ITEM NO FDP #130003

MEETING DATE May 30, 2013

STAFF REPORT

PROJECT: Boardwalk Crossing at Mason Street, Project Development Plan/Final Development Plan - FDP #130003

SITE PLAN
BOARDWALK & MASON

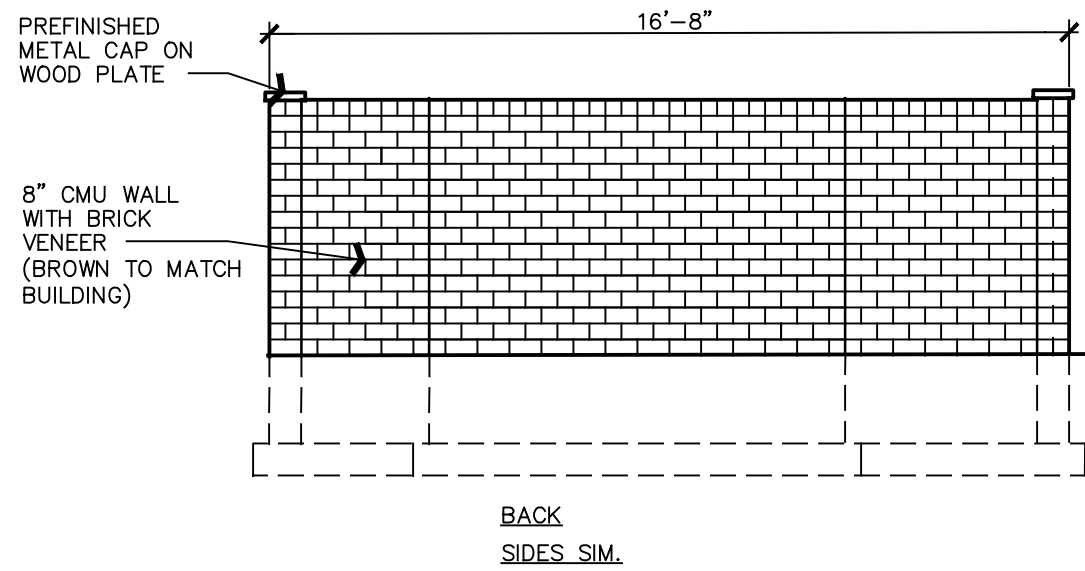
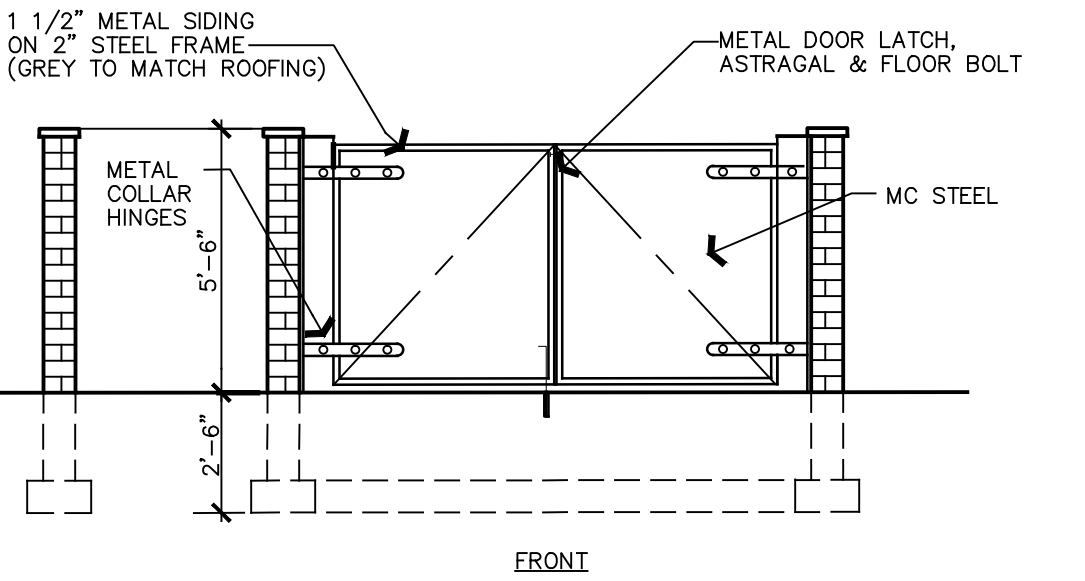
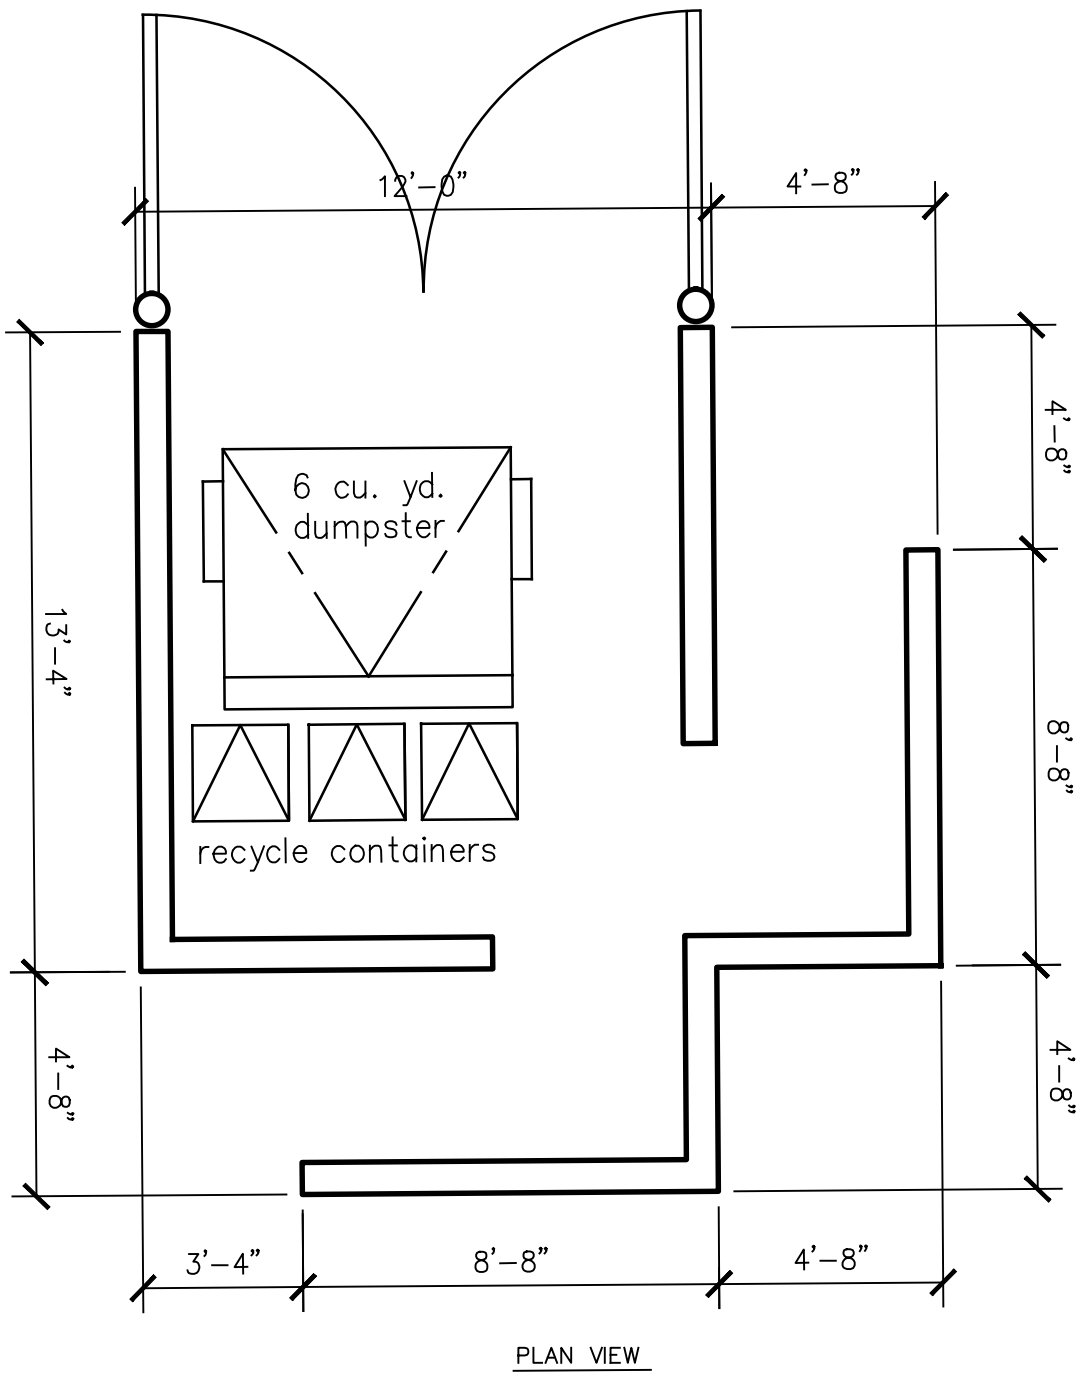
First Modification - Section 3.2.2 (J) – Setbacks: This standard requires “*any vehicular use area containing six (6) or more parking spaces or one thousand eight hundred (1,800) or more square feet shall be set back from the side and rear lot lines by 5’*” in order to provide a landscape area to screen and buffer parking along the lot lines. The proposed landscape setback is between 0’ and 3’ along the rear lot line, with no proposed new landscaping. The abutting development comprises parking in the rear of a large retail establishment, with a 5-foot perimeter landscape area.

Staff acknowledges the hardship for commercial development of the parcel based on its narrow dimension of 110 feet from South Mason Street to the east lot line. While the proposed PDP/FDP includes only a partial landscape setback along the rear lot line ranging from 0' to 3', staff finds that the existing 5' landscape area along the rear lot line of the abutting rear parking lot of a retail building provides adequate landscaping for screening and buffering the proposed drive aisle along the lot line. Doubling the shrub screening with an additional 5-foot landscape strip between the abutting parking lot and the proposed drive aisle would have a small effect that would not affect the public good in a significant way.

Second Modification: Section 3.2.2 (J) – Setbacks: This standard requires any vehicular use area containing six (6) or more parking spaces or one thousand eight hundred (1,800) or more square feet to be set back from the street right-of-way by a minimum dimension based on the type of street. This stretch of South Mason Street is an arterial street, which requires a 15-foot average width landscape area for parking along the right-of-way, and the proposed landscape setback area is 6 feet, resulting from the layout of proposed parking, which is constrained by the narrow lot.

The proposed deviation of the required 15' landscape setback from street right-of-way is approximately 9'. The utility easement along S. Mason Street includes an underground gas line. Staff assessed requiring a 30" high stone or masonry screen wall within the proposed 6' landscape area, and determined this is not feasible given the constraints mentioned above. Additional landscape planting is included in the planting plan to provide sufficient screening of parking from the street.

The modification as proposed would result in a reduction of landscape setback, yet staff has determined adequate landscape screening is provided for the parking area between Buildings 2 and 3 adjacent to S. Mason Street. Staff agrees with the applicant that the requested modification poses a hardship and does not diverge from the standards except in a nominal, inconsequential way when considered from the perspective of the entire development plan.

Third Modification - Section 3.10.4 (C) – Off-Street Parking: This standard requires that “*off-street parking shall be located only behind, above or below street-facing buildings. No parking will be allowed between the street and the front or side of a building.*” The intent is to promote attractive, pedestrian friendly streets and mitigate the effects of vehicle parking. Proposed parking spaces along Mason Street extend closer to the street than Building 2, by several feet.

As an infill site and existing narrow lot width poses a hardship. The proposed deviation of the standard requiring off-street parking behind street-facing buildings is nominal, extending beyond the buildings by only a few feet. Screening of this parking area is important, including separating this vehicle use area from the street and pedestrians walking along the street on the sidewalk. While the proposed landscape setback is narrow (6') rather than the required 15', it allows for reasonable landscape screening given the site constraints, and also considering the compatibility of the whole development plan in the context of surrounding commercial uses. Staff finds that the modification to this standard will not diverge from the standard except in an inconsequential way.

Staff recommends approval of the Modification. In evaluating the request and in fulfillment of the requirements of Section 2.8.2(H) (3) (4), Staff makes the following findings of fact:

Staff recommends approval of the Modification. In evaluating the request and in fulfillment of the requirements of Section 2.8.2(H)(3)(4), Staff makes the following findings of fact:

Staff recommends approval of the request for Modification to 3.10.4 (C) Off-Street Parking. In evaluating the request and in fulfillment of the requirements of Section 2.8.2(H) (3) (4), Staff makes the following findings of fact:

LANDSCAPE PLAN
BOARDWALK & MASON

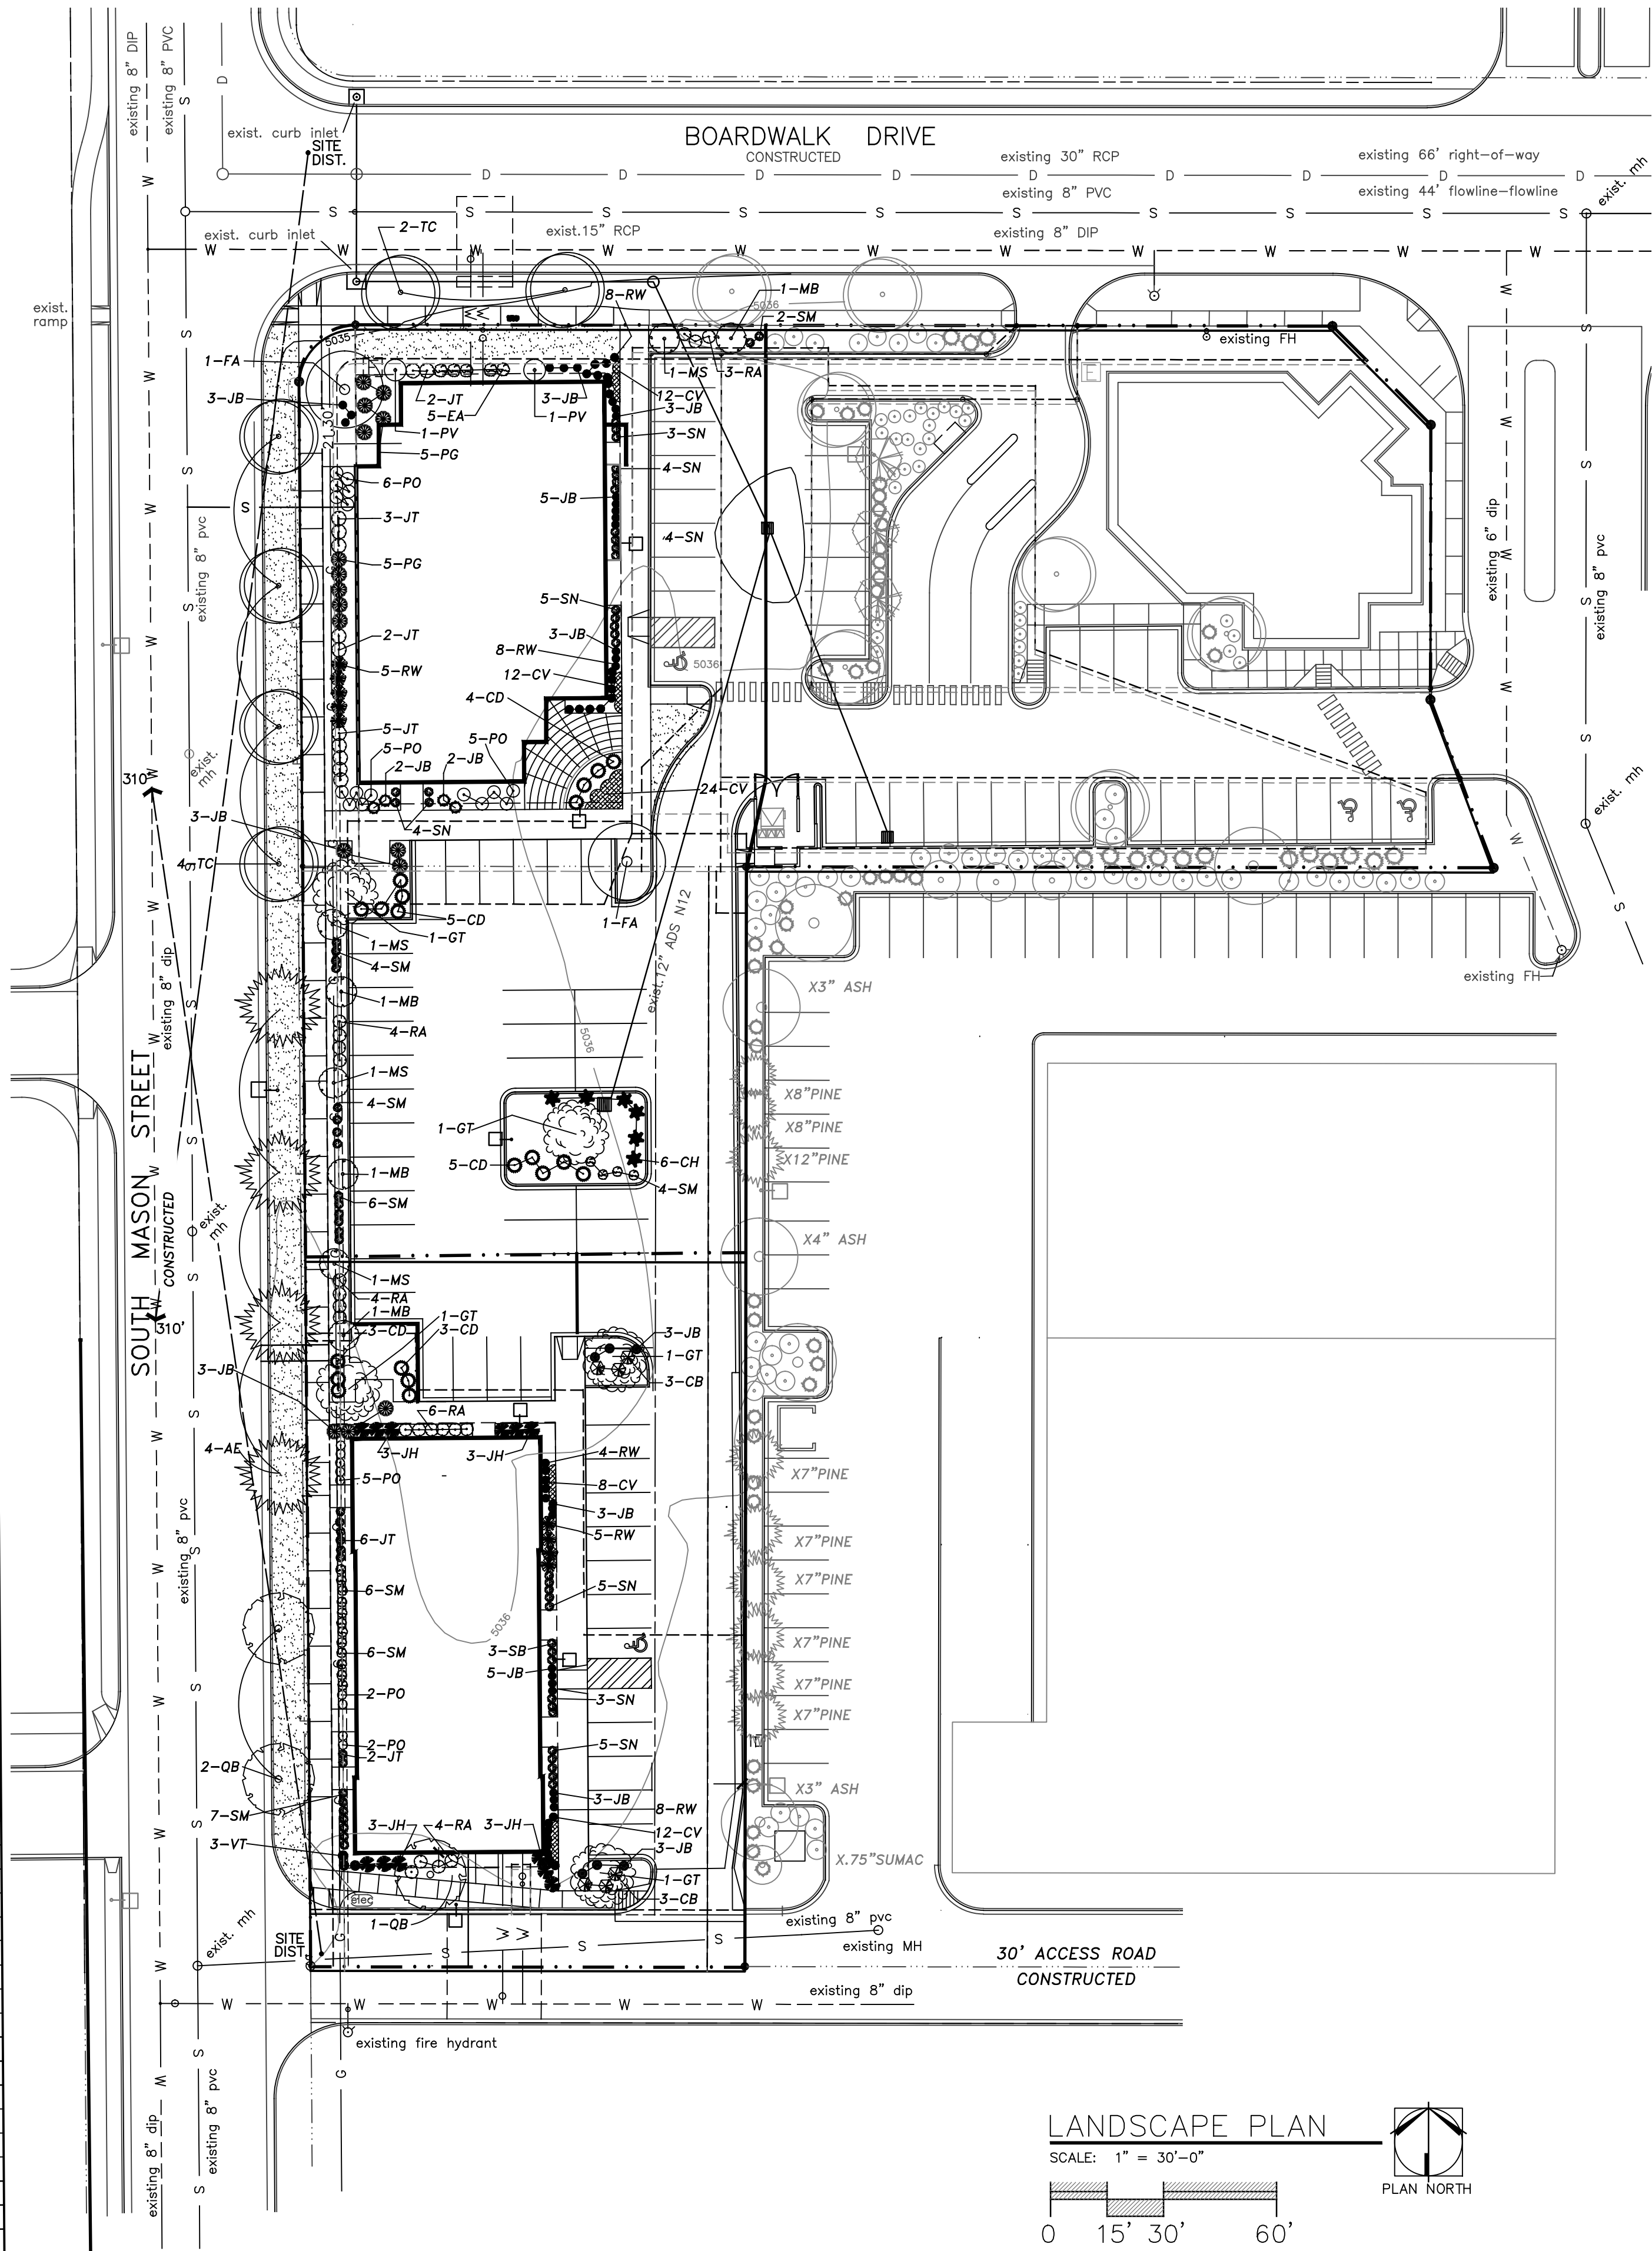
The landscape plan complies with the landscape standards for perimeter, building foundation, and interior parking-island planting. The perimeter parking areas are screened from the street and abutting uses by providing sufficient ground plane and tree canopy plantings to screen at least 75% of the light from headlights, to a minimum height of 30" for at least 70% of the length of the parking area along the street. Staff evaluated the potential use of a low 30 inch tall masonry wall in lieu of planting to screen parking areas abutting S. Mason Street. Due to the narrow landscape area (six feet wide) and utility lines underground, staff determined a wall is not feasible and requested substantial shrub planting to screen parking.
